OR-5007/URC AND 719D-2A RECEIVER-TRANSMITTER GROUP (622-1407-XXX)  
AM-5280/URC AND 549A-2 AMPLIFIER-COUPLER A3 (622-2149-001, -002, -003)  
POWER AMPLIFIER A3A4 (629-3410-001)  
RF SUBASSEMBLY A3A4A1 (601-3674-001, -002)

**SERVICE BULLETIN NO 1****REDUCE T/R RELAY FAILURES**

## SERVICE BULLETIN NO 2

### LIMIT TRANSISTOR CURRENT DURING TUNE

P/O Rf Subassembly A3A4A1  
Figure 1

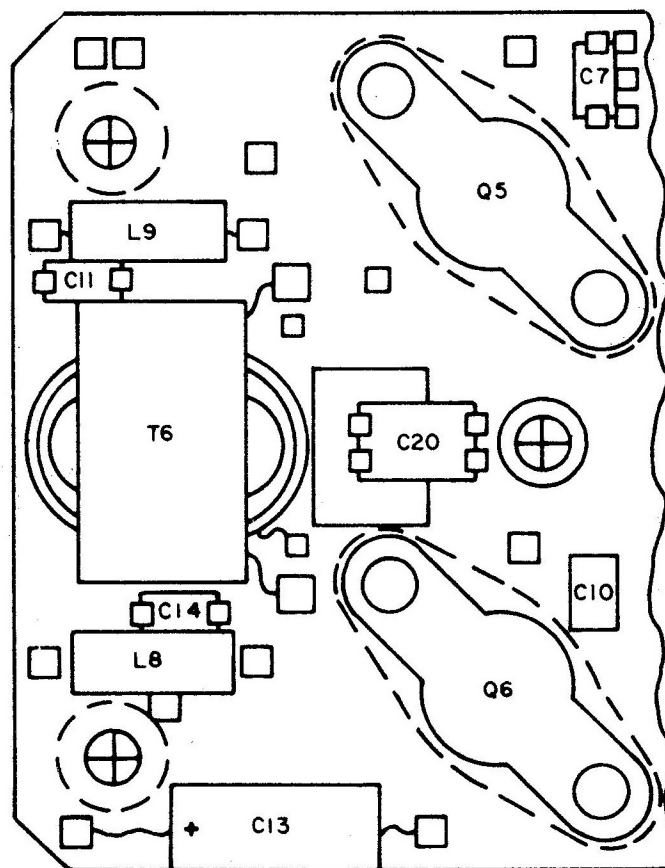
This service bulletin removes capacitor A3A4A1C13.

C. Refer to figure 1 of this bulletin for location of component and remove capacitor C13.

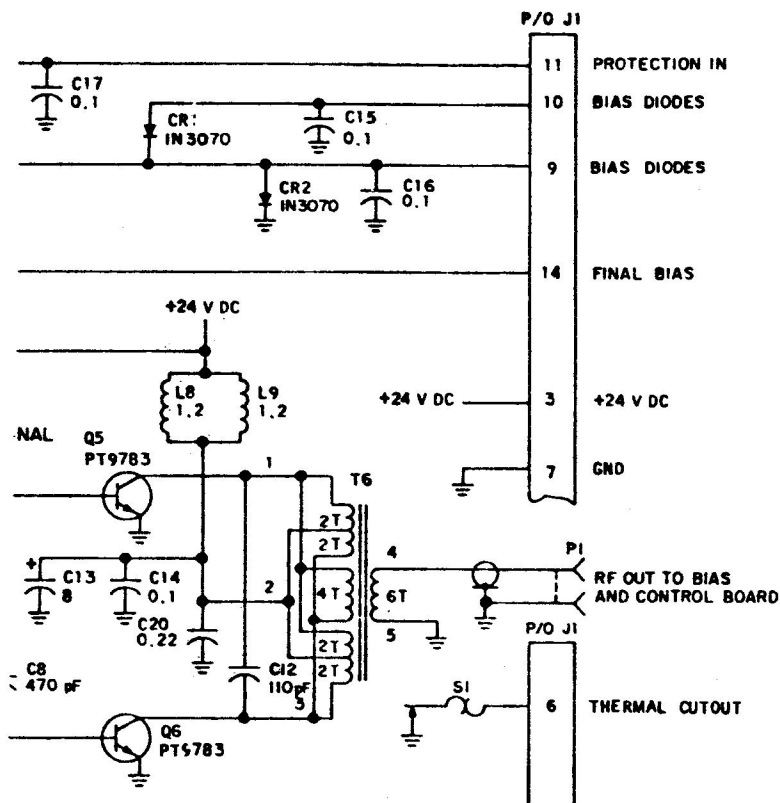
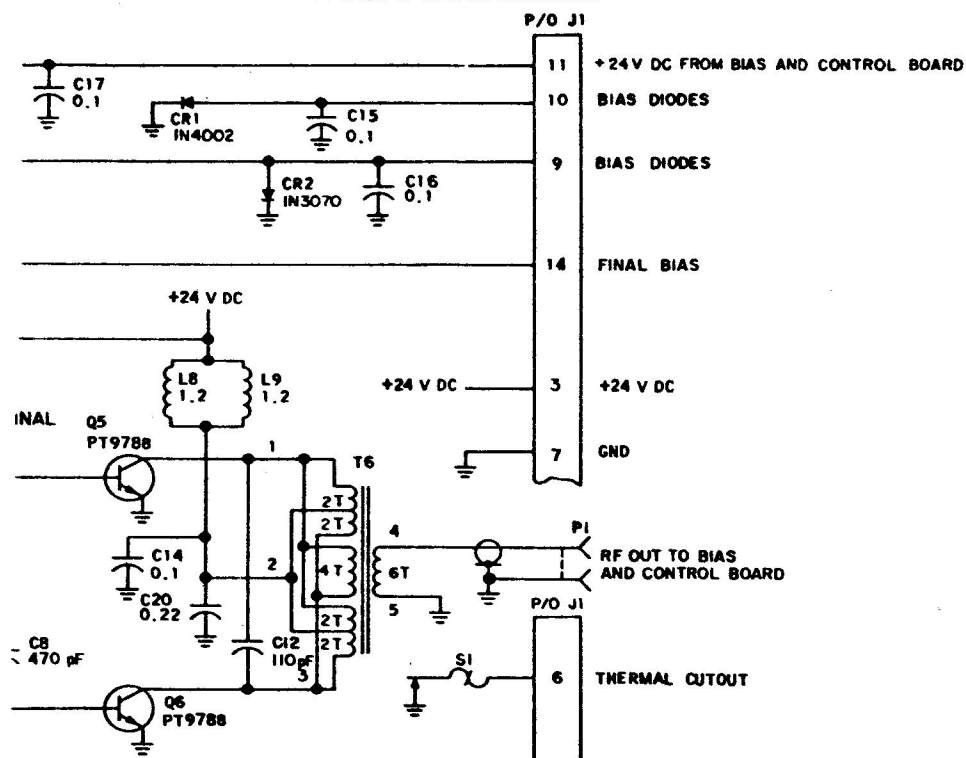
The high inrush current required to charge capacitor C13 on rf subassembly A3A4A1 causes premature failure of tr relay K1 on filter board A3A3A1. If failure of K1 is noted by abnormally low battery life, then incorporation of this service bulletin is required when the relay is being replaced. Bypass capacitor C13 may be removed without degrading performance because of the proximity of the low-impedance power source.

NOTE: Refer to figure 2 for before and after schematic diagrams of the rf subassembly.

Loading Board A3A6A2  
Figure 1

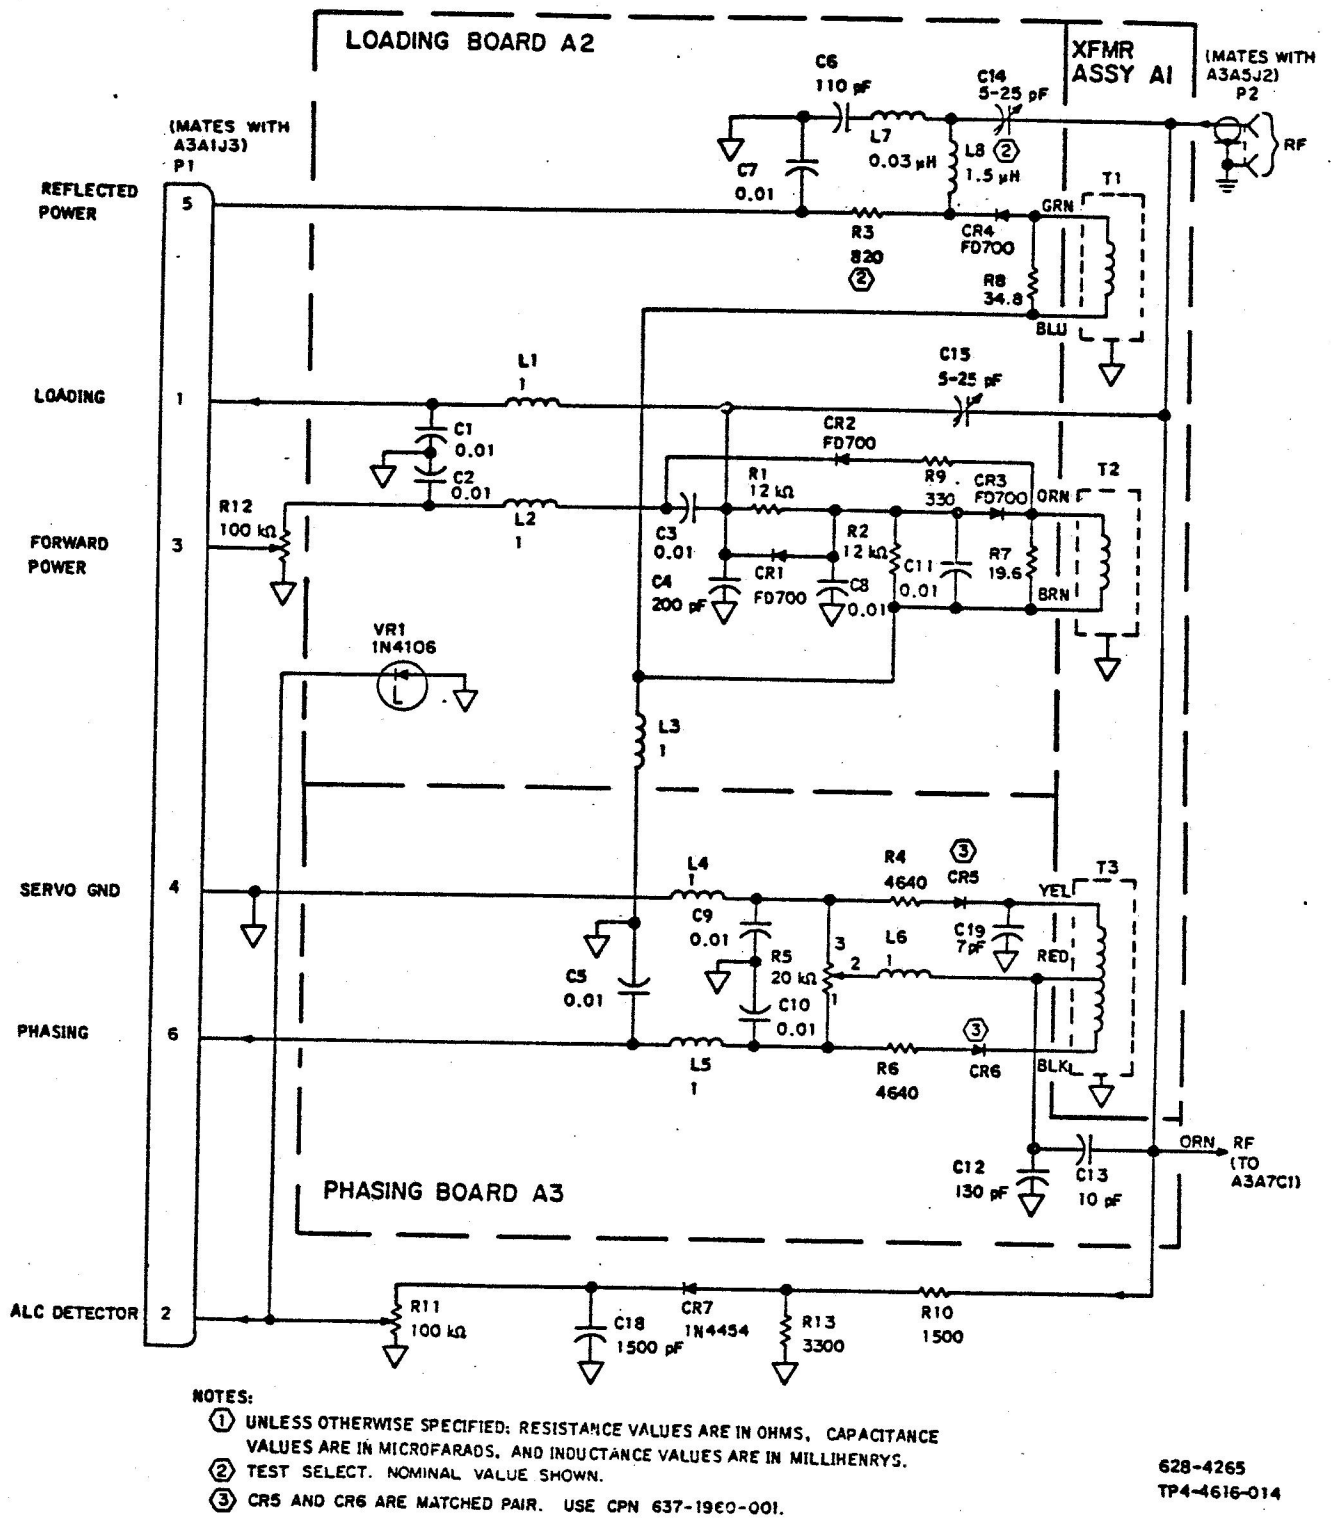
NOTE: Refer to figure 1 of the service bulletin while performing steps G and H. Refer to figure 2 for a schematic diagram that includes the new diode.

- F. Insert a pin (372-2601-033) into hole next to symbol Z in figure 1.

- G. Install 1N4106 zener diode VR1 (353-3591-080) from new pin (cathode) to hole (anode) shown in figure 1.

Discriminator A3A6, Schematic Diagram  
Figure 2

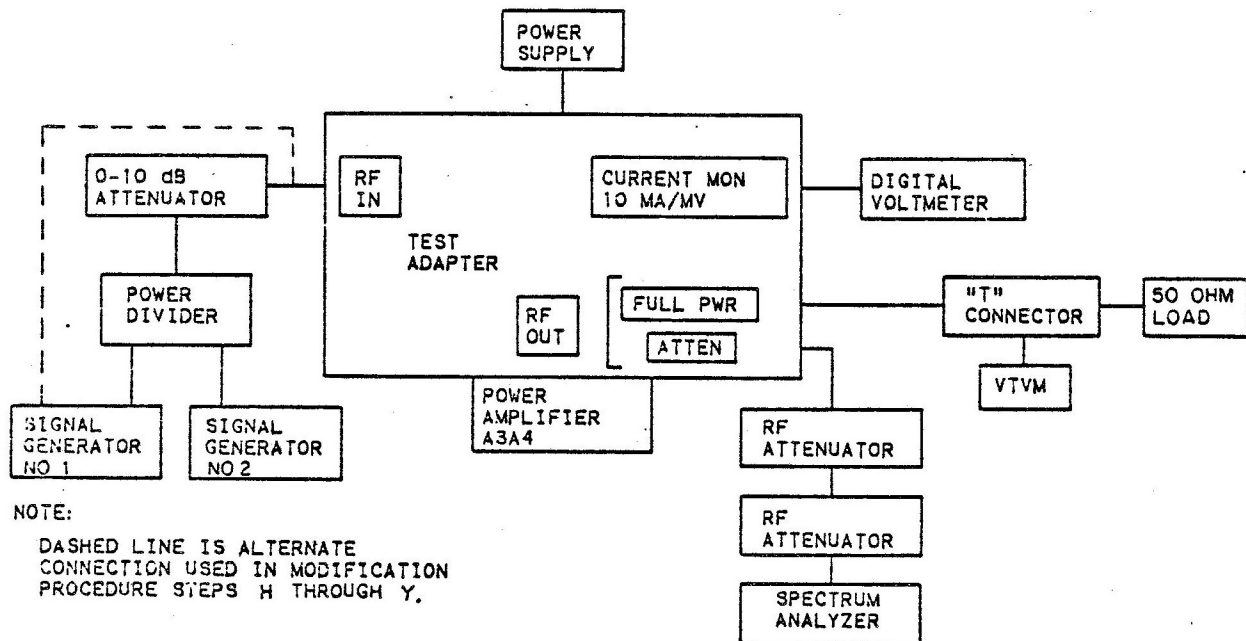
One zener diode is removed from the discriminator to prevent saturation of ALC during tune mode. A zener diode is added to the loading board to limit ALC voltage to 12 volts. Peak bias current is limited by changing one resistor on the bias/control card and six resistors on the rf subassembly card. Amplifier gain variations when using various transistor vendors is kept to a minimum by test selecting five of the resistors.

- E. Refer to instruction book, figure 3-27, item 8, for location of zener diode A3A6VR1. Remove and discard VR1.

Bias/Control A3A4A2 (601-3675-002)  
Figure 5

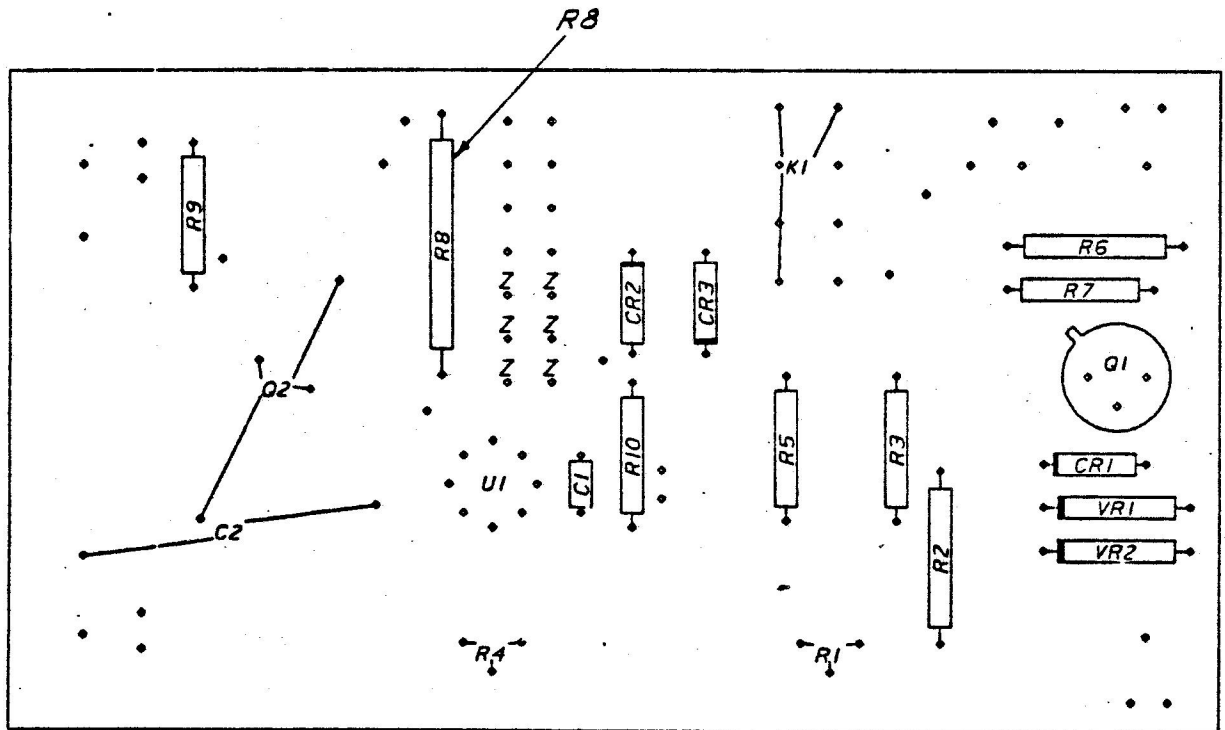
- X. On test adapter, set KEY switch to ON, set signal generator frequency to 29.99 MHz, and increase signal generator drive to produce output of 31.6 V rms measured on multimeter.
- Y. Measure dc voltage at bias/control card Q2 collector. Test-select resistor R8 (table 2) on bias/control card for a voltage of +10.0 to +15.0 V dc at Q2-C.

RF Subassembly A3A4A1 (601-3674-002),  
Schematic Diagram  
Figure 7

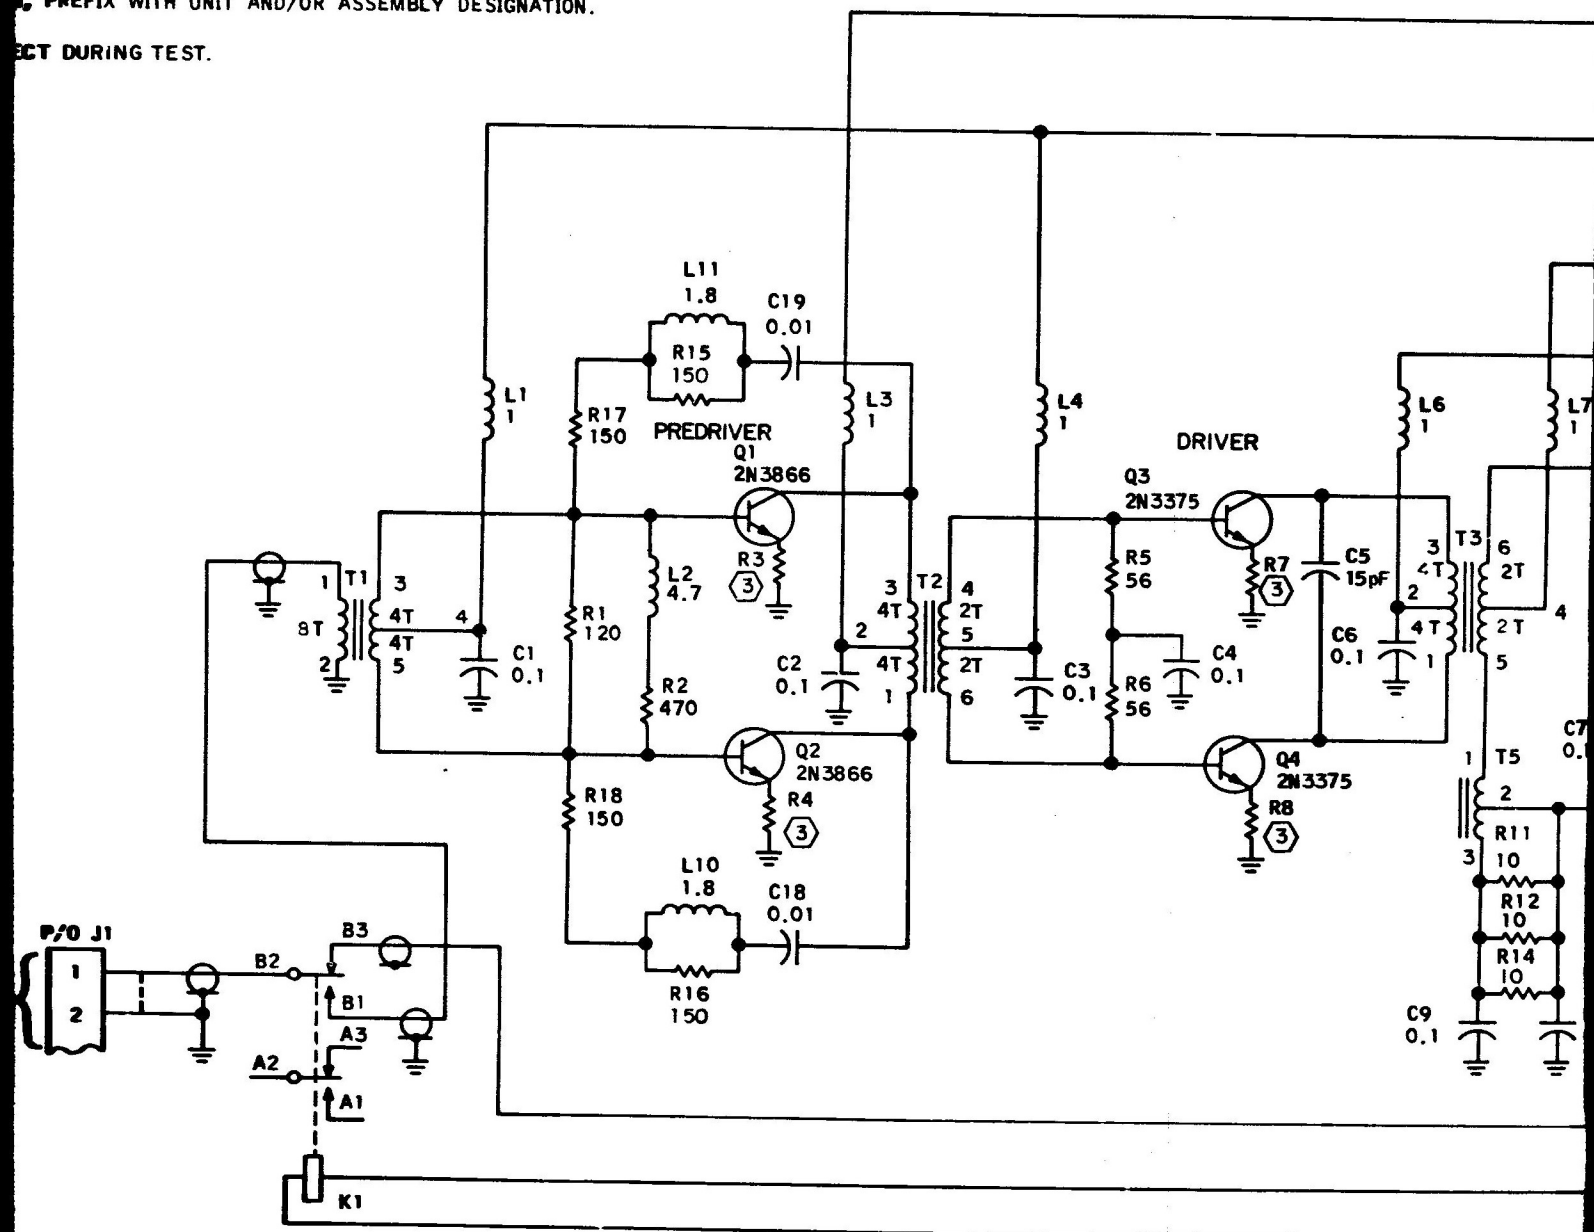
- I. On A3A4A1 card (figure 4), remove 39- $\Omega$  resistors R15 and R16, and replace them with 150- $\Omega$  resistors (745-0718-000).

- U. Test-select resistors R3, R4, and R7, and R8 (table 1) to meet the drive voltage and dc current requirements of step T. When a resistor is removed, install a pin (372-2601-033) in each hole where a resistor lead is removed. The new resistors will be connected between the pins. Resistors R7 and R8 can be one step higher or lower than R3/R4, but R7 and R8 must be the same value. When the test selects are changed, the bias must be readjusted according to steps M through Q.
